# **VISUAL INSPECTION REPORT**

**LEO ROY PARKING GARAGE**

**100 MARKET STREET**

Photo 11: Standing puddle at bottom of down ramp on 2<sup>nd</sup> floor

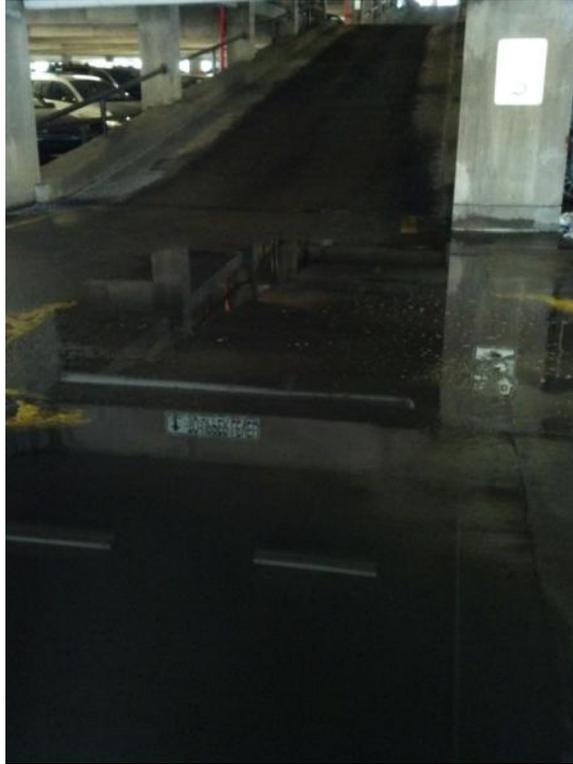
At the bottom of the down ramp, which is the expansion joint of the floor deck, there is heavy ponding of water; this puddle can cause water leakage and consequently may lead to corrosion of rebars and also deterioration of concrete. **See Photo # 11.** This is a typical problem on 3<sup>rd</sup> and 4<sup>th</sup> floor.

Photo 20: Melting snow stockpile on roof deck

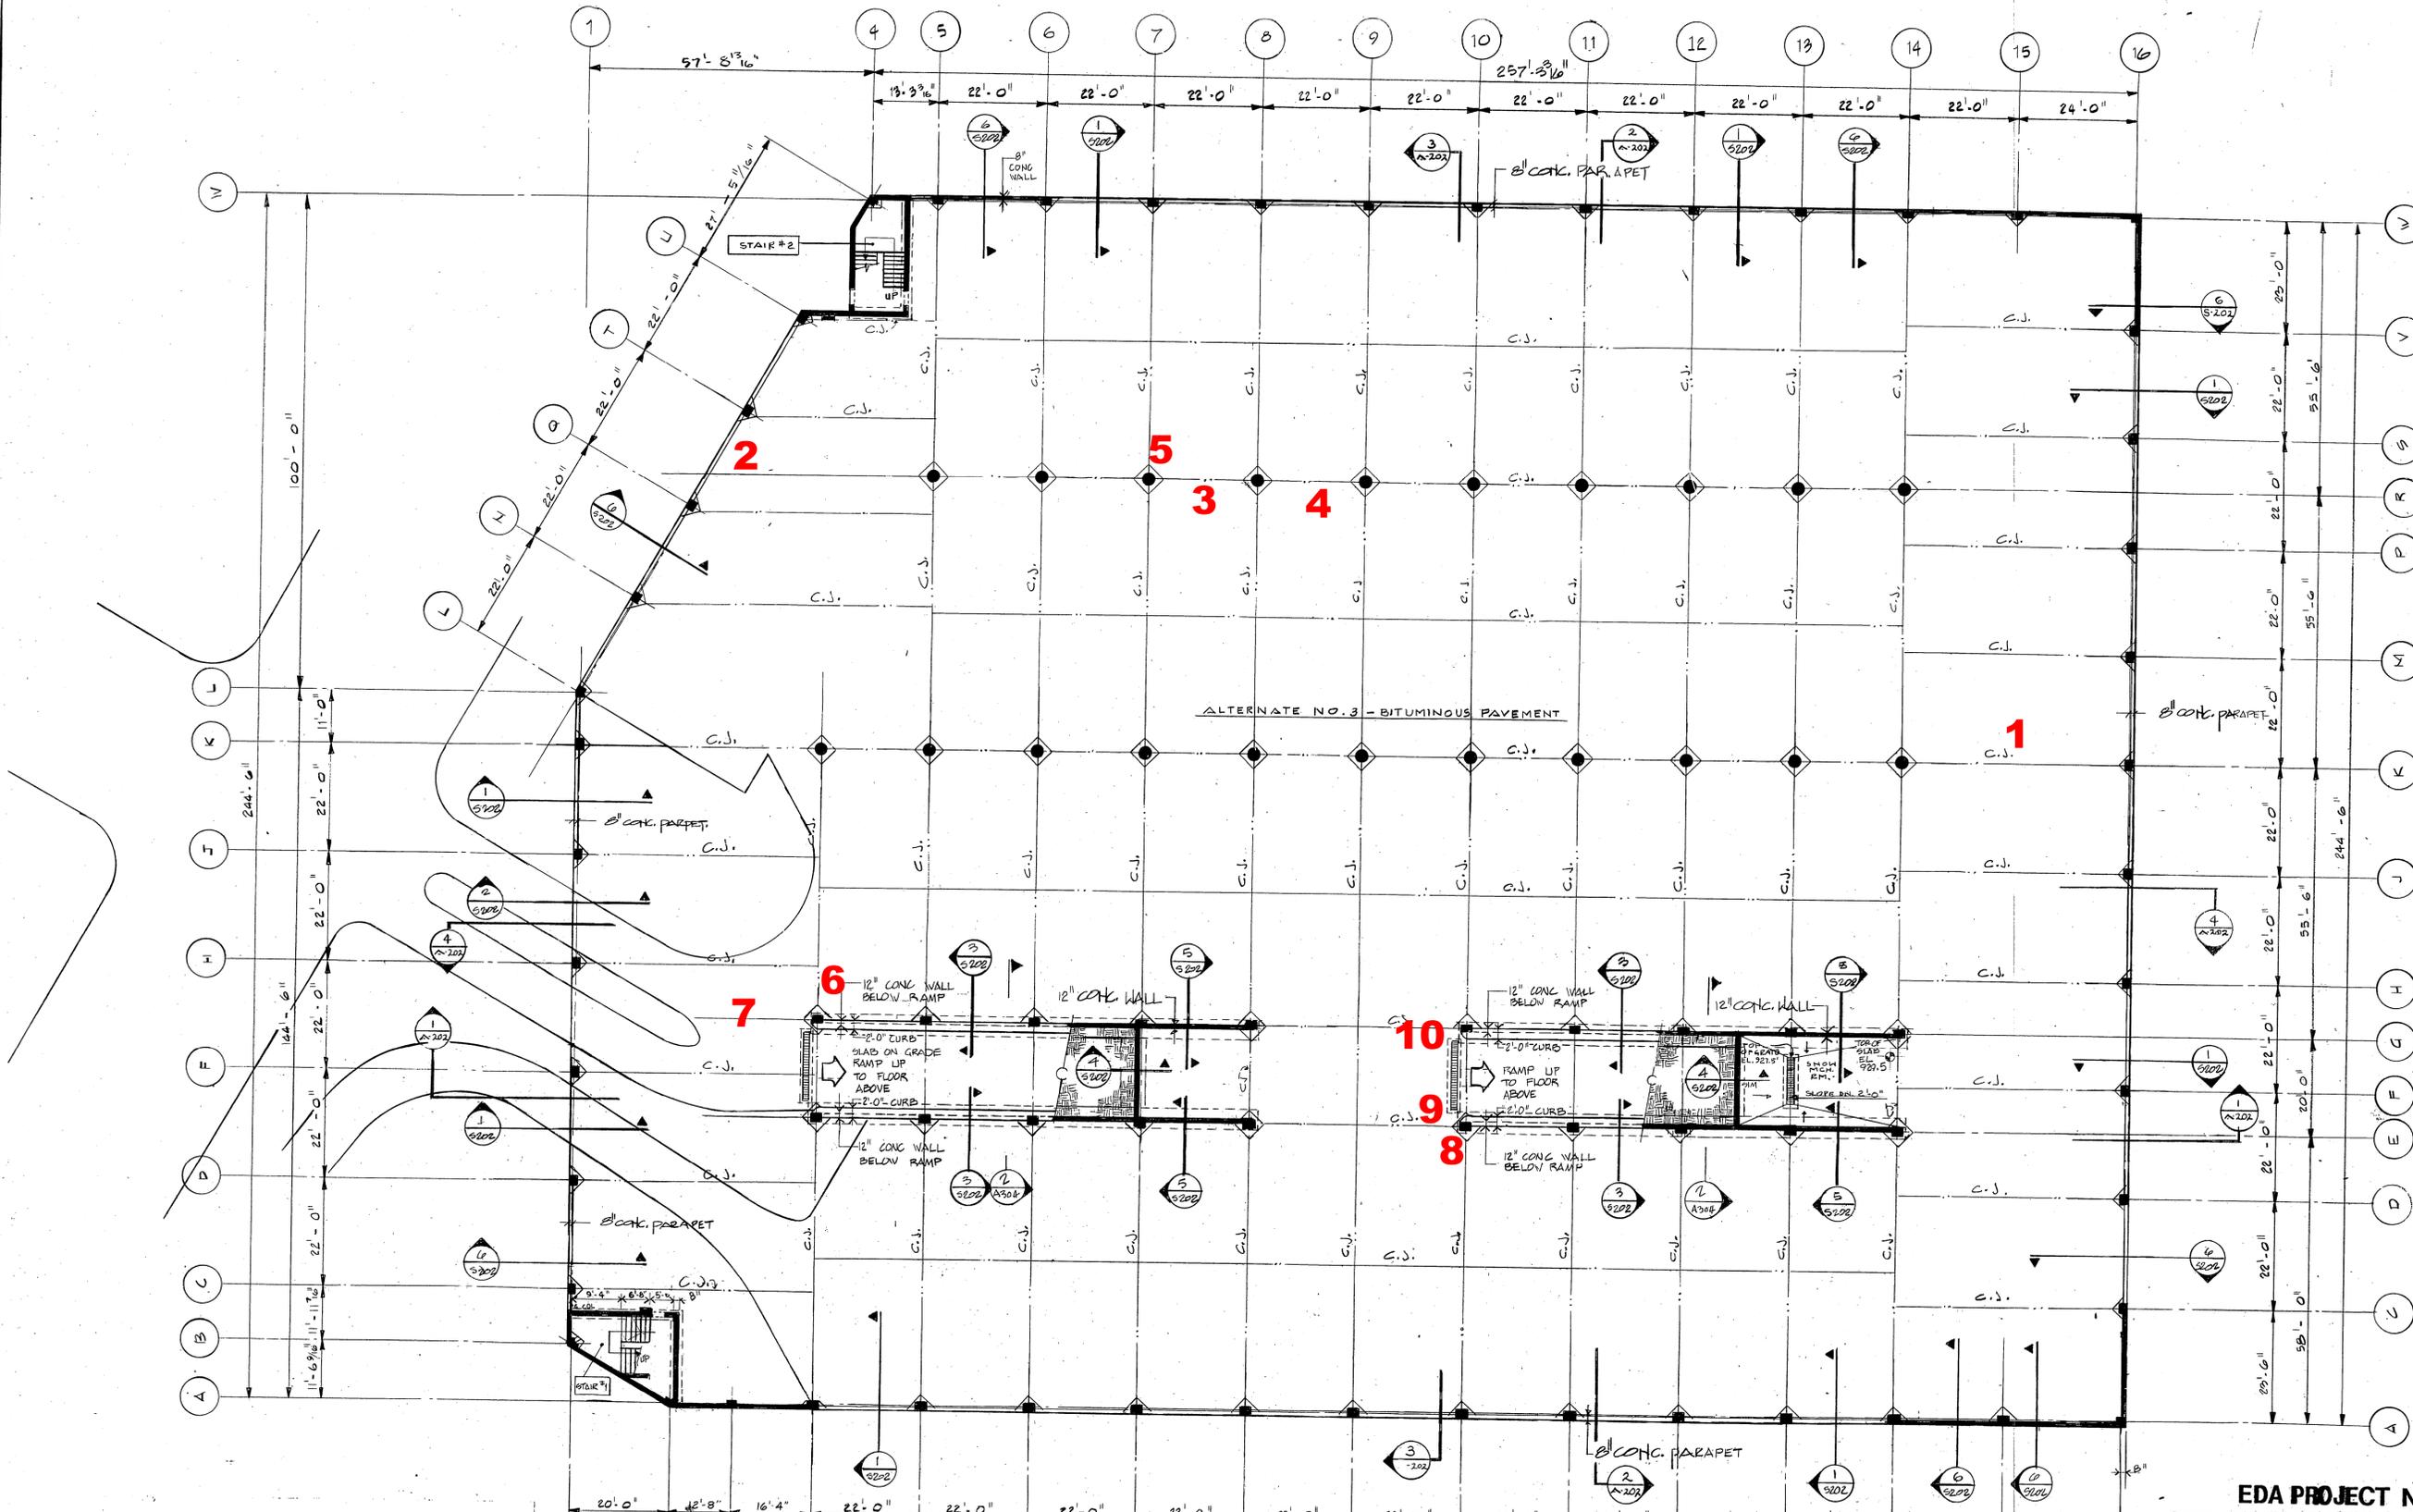
The floor slab shows some minor scaling and uneven patching. There is also a pile of snow which can cause deterioration of the reinforced concrete. The stockpiling of snow other than on the first floor should be avoided. This melting snow, often containing deicing salt, can lead to progressive chloride infiltration into the concrete surface as well as possible overload of the structure's capacity. Clogged drainage further magnifies this problem as melt water cannot drain. Snow stockpiles were also observed on other floors. **See Photo # 20.**
